November 1, 2024
Refer to OP- 4711

Subject: Former Roundhouse Area Nexus
Union Road Site, Erie County, Cheektowaga, NY
Inactive Hazardous Waste Disposal Site No. 915128

Unicorn Management Consultants, LLC (UMC), on behalf of American Premier Underwriters, Inc. (APU), has prepared this Union Road Project History Nexus (Nexus) pursuant to conference calls attended by APU and New York State Department of Environmental Conservation (NYSDEC) representatives on August 28, 2024, and September 25, 2024, as well as NYSDEC correspondences dated October 31, 2022, September 7, 2023, May 28, 2024, and September 6, 2024. The Nexus presents information, reviewed by UMC/APU between 1982 through 2024, related to the former roundhouse area investigations, remediation, orders/directives, operation, maintenance, and monitoring as they relate to NYSDEC's requests for additional remedial investigation and potential remedial actions related to the former roundhouse area at the Union Road Site submitted to UMC/APU between 2022 through 2024. The objective of the Nexus is to present information from the Union Road Administrative Record to assist NYSDEC with the reevaluation of their directives presented i

Figure 5-2

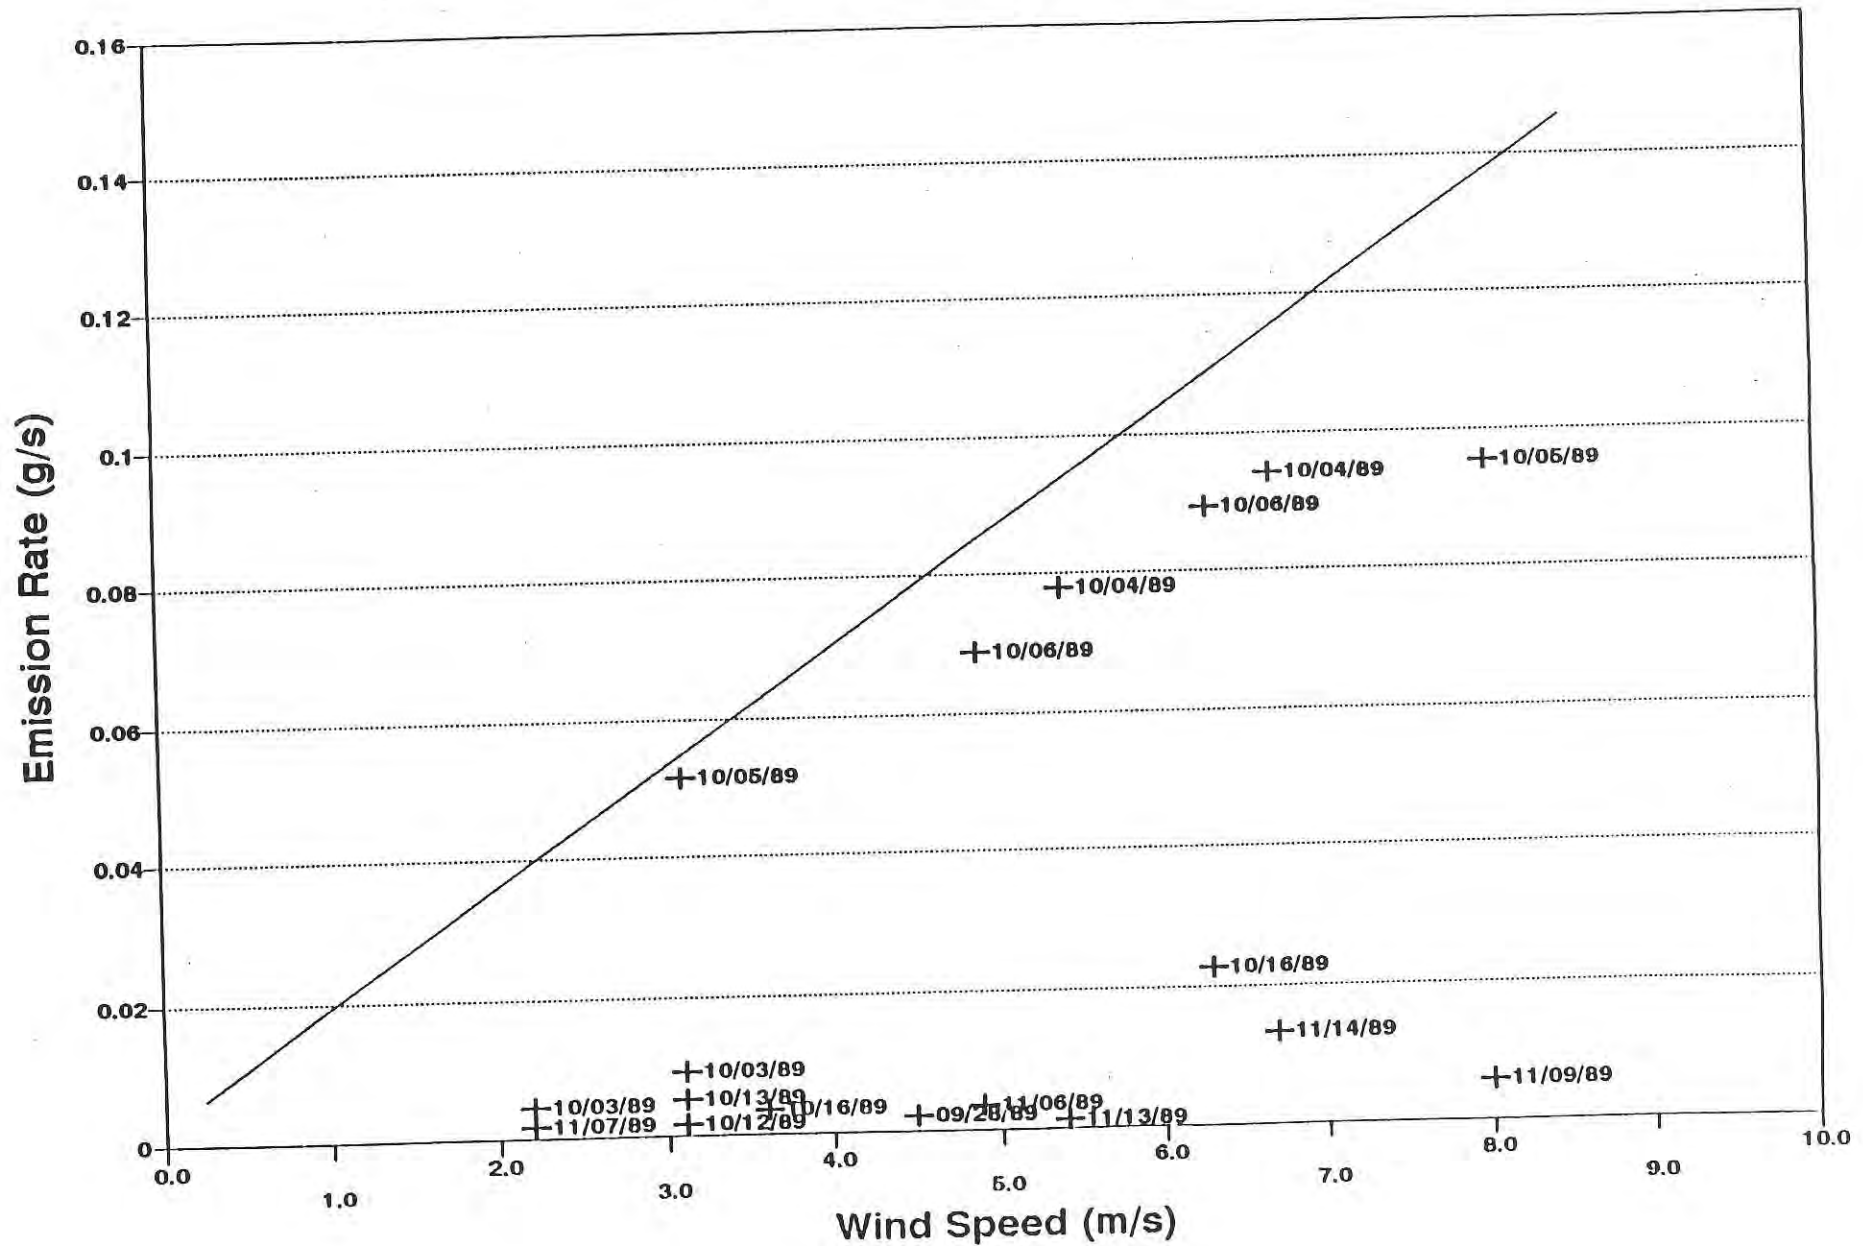
- EPA's default value for frequency of exposure for residents is 350 days, not 365 days as used in the HHRA;
- Figure 5-2 in the HHRA (attached) indicates that the estimated slope from the emission rate with respect to wind speed does not fit the data because the line is drawn such that all of the site-specific data lies below the line. The HHRA selected an estimated emission rate for wind erosion (0.14 grams/second; HHRA, p. 5-10) at the maximum observed wind speed (8 m/second; HHRA, p. 5-10) which does not reflect actual site conditions. The actual site-specific emission rate measured at a wind speed of 8 m/s is approximately 0.095 grams/second.

On page 5-7 of the HHRA, it is stated that "As can be seen in the figures, all of the site-specific readings result in emission rates fall in the area of the graph below the estimated slope" (emphasis added). This is clearly a worst case assumption which is inconsistent with the accepted risk assessment practice of evaluating RME. The site-specific readings should have been evaluated to determine a "best fit" line through the actual data; based on this line, a more representative value, perhaps the 90th percentile value, should have been used to determine the emission rate;and

FIGURE #
2-6

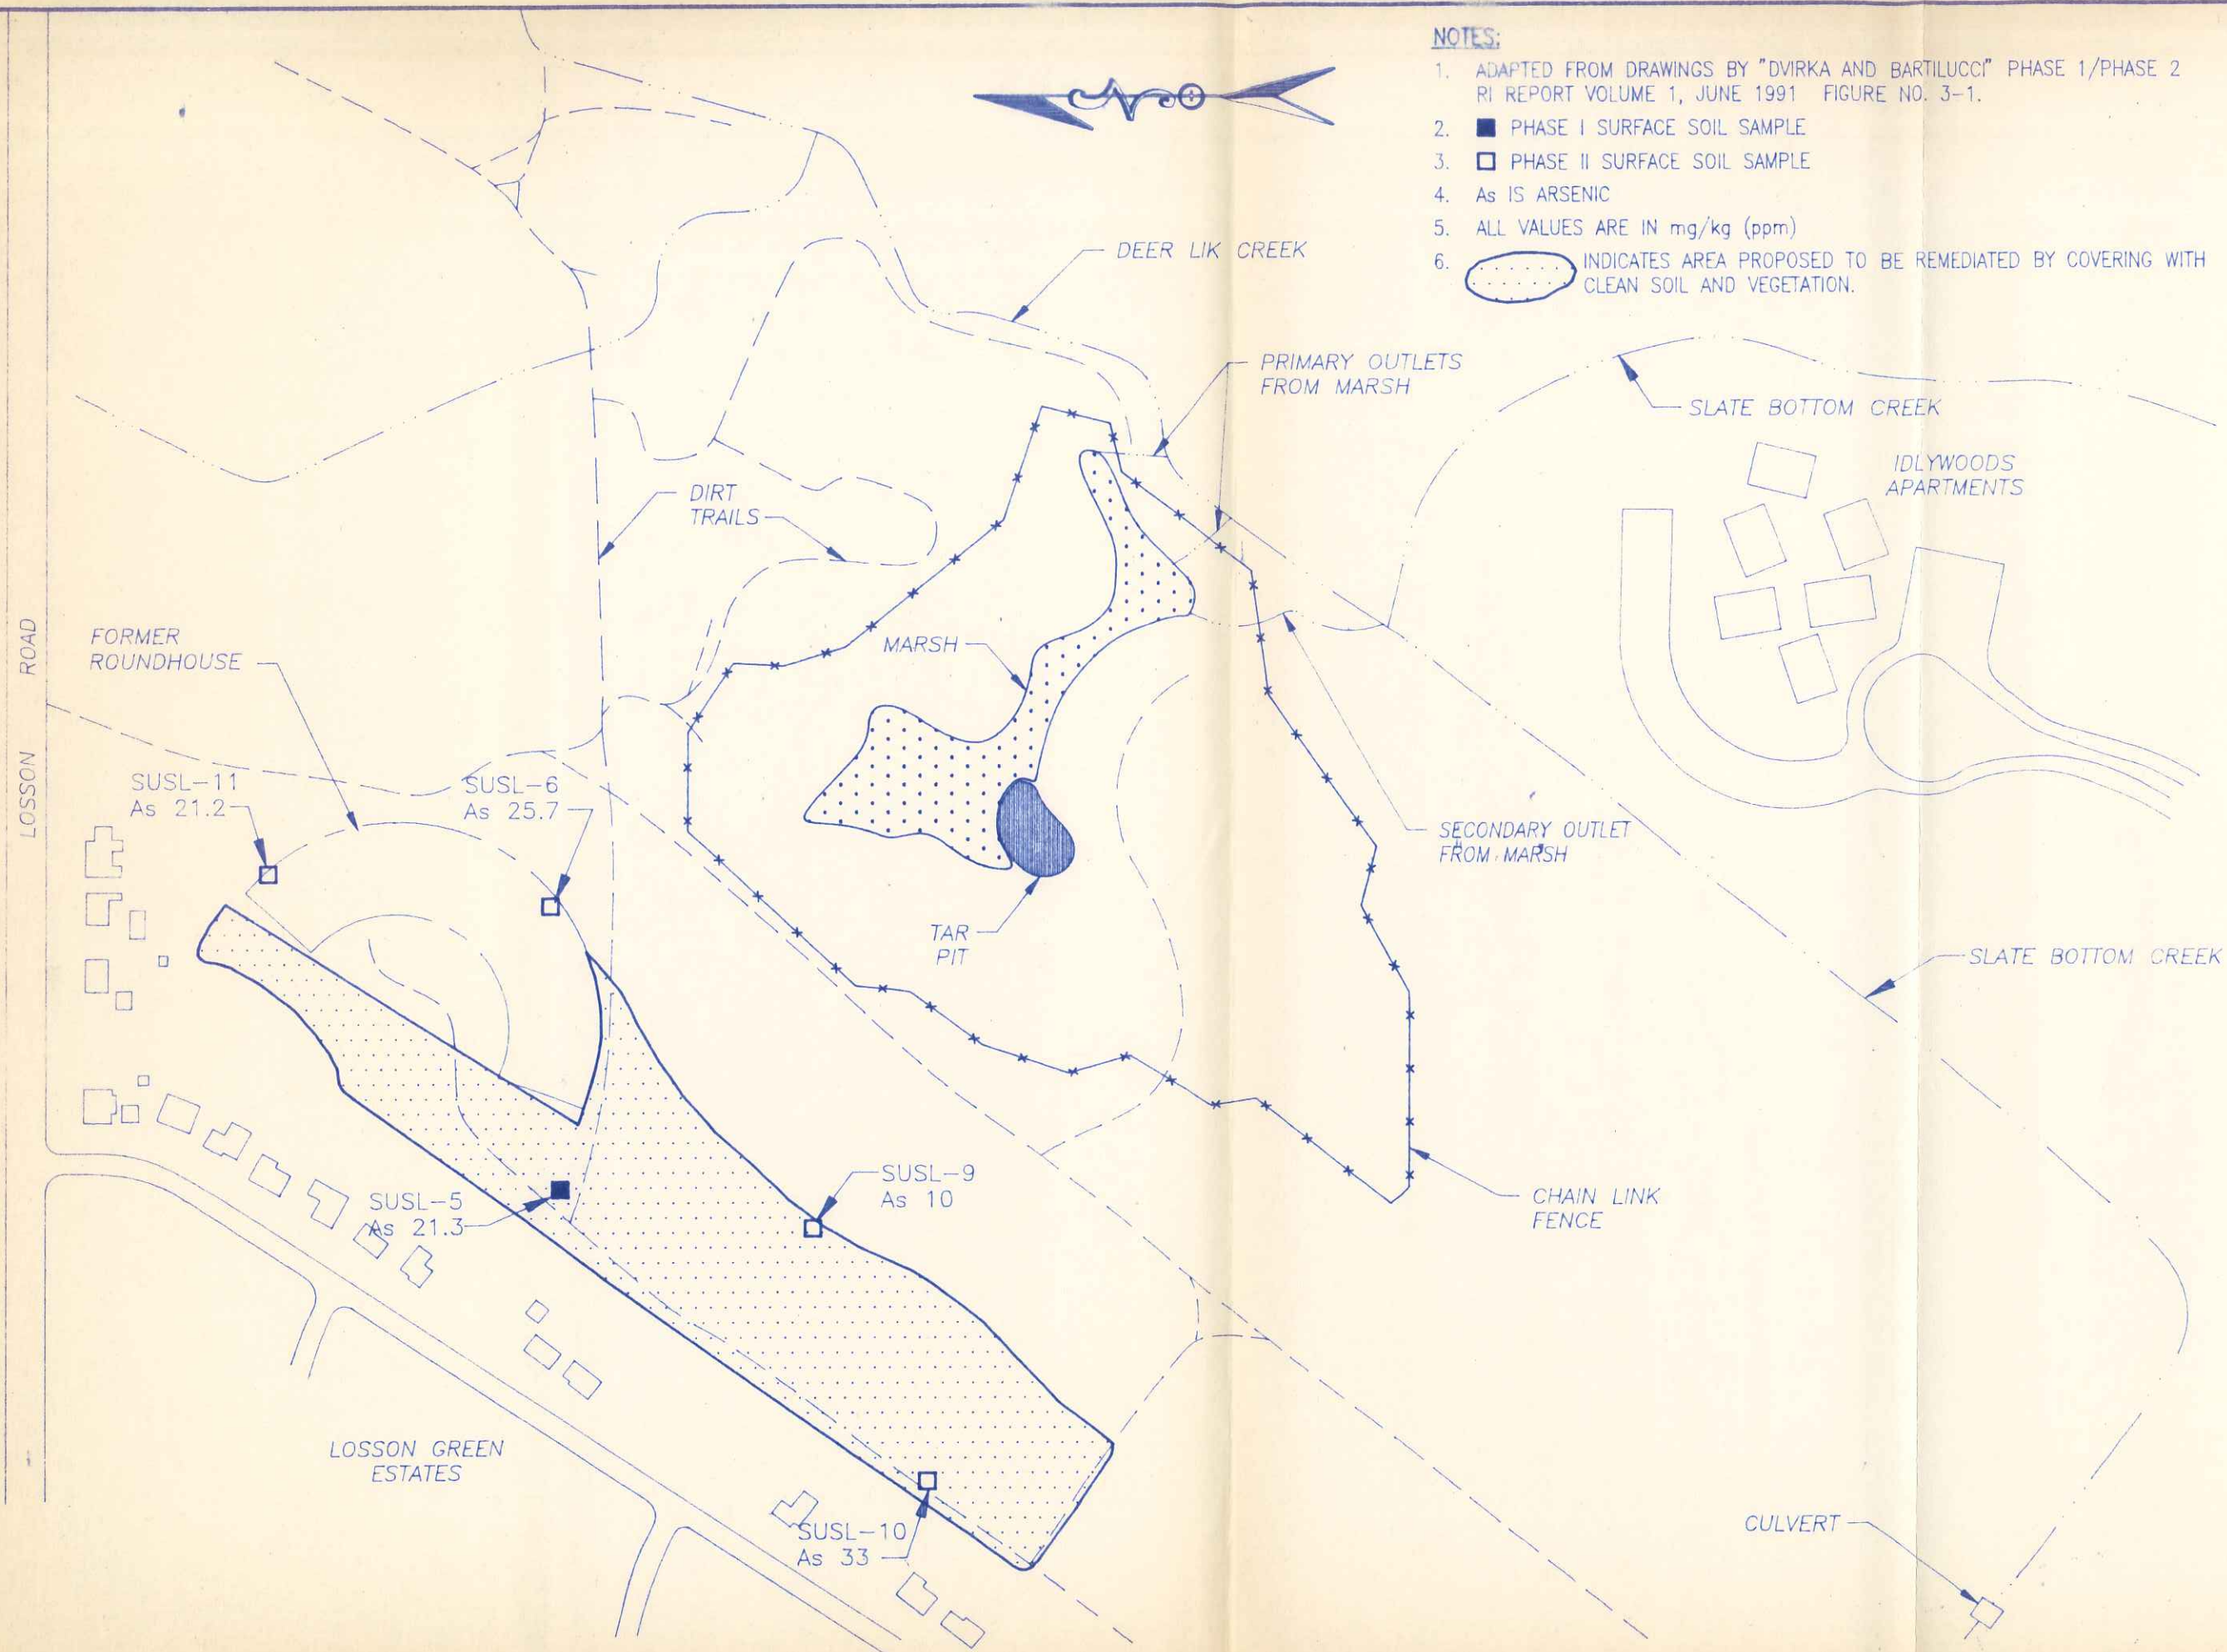
2.4.3 Difference Between This Remedial Measure and the ROD. Remediation of this area discussed in the ROD involved placement of one foot of clean soil cover over approximately 7.5 acres. This area would then be vegetated. Additionally, land use restrictions would be cited in the deed and access restrictions will be considered.

The remedial proposal for this area contained herein involves a smaller area (approximately 5 acres) and placement of six inches of clean fill prior to re-vegetation.

The reduction in area is due to the presence of the structures of the former roundhouse which remain on site. These structures include large concrete foundations and walls; several large holes and openings to underground portions of the former roundhouse are present. Due to these structures and openings, this area is not amenable to covering with a layer of clean soil i.e. the openings would need to be filled and the concrete removed in order to provide a base to cover with soil.

- 2) Remediation in the Roundhouse Area: The placement of the six inches of clean fill over approximately five areas of roundhouse area is acceptable, provided this area is restricted for any future activity. The question of other types of restriction will be dealt separately by legal personnel.
- 3) Citizen Participation Plan: Item I-8 of the Order On Consent requires the PRP to include a Citizen Participation Plan (CPP) in the remedial design. The NYSDEC will develop a site specific CPP and the PRP will assist NYSDEC in implementing the following plan requirements:
 - Provide copies of all necessary documents to the local repository.
 - Assist with meeting room arrangements, mailing to citizens, legal notices if required, participation in public meetings; arrange for legal transcripts if needed; and meet any other requirement as outlined in the CPP.

Figure 5-2

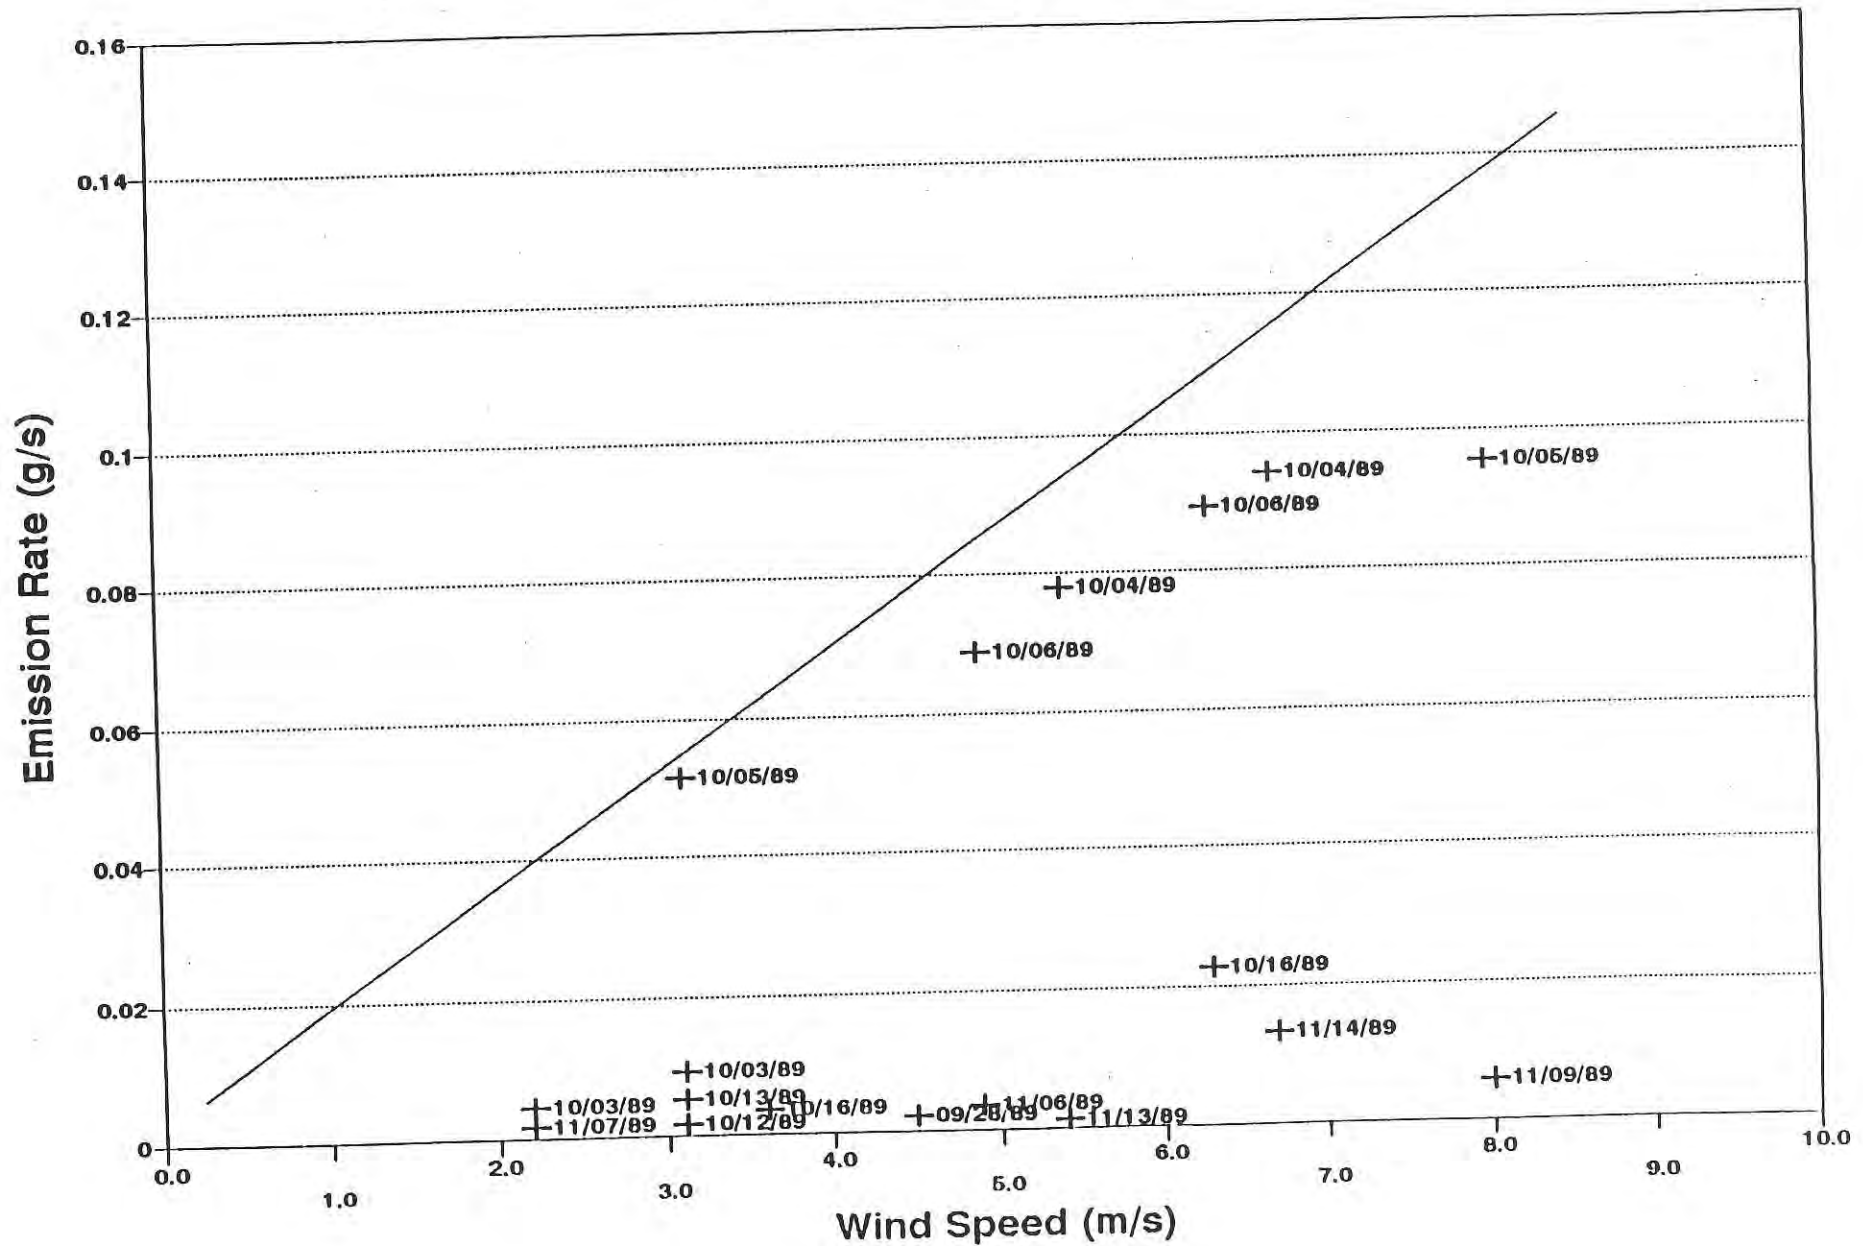
- EPA's default value for frequency of exposure for residents is 350 days, not 365 days as used in the HHRA;
- Figure 5-2 in the HHRA (attached) indicates that the estimated slope from the emission rate with respect to wind speed does not fit the data because the line is drawn such that all of the site-specific data lies below the line. The HHRA selected an estimated emission rate for wind erosion (0.14 grams/second; HHRA, p. 5-10) at the maximum observed wind speed (8 m/second; HHRA, p. 5-10) which does not reflect actual site conditions. The actual site-specific emission rate measured at a wind speed of 8 m/s is approximately 0.095 grams/second.
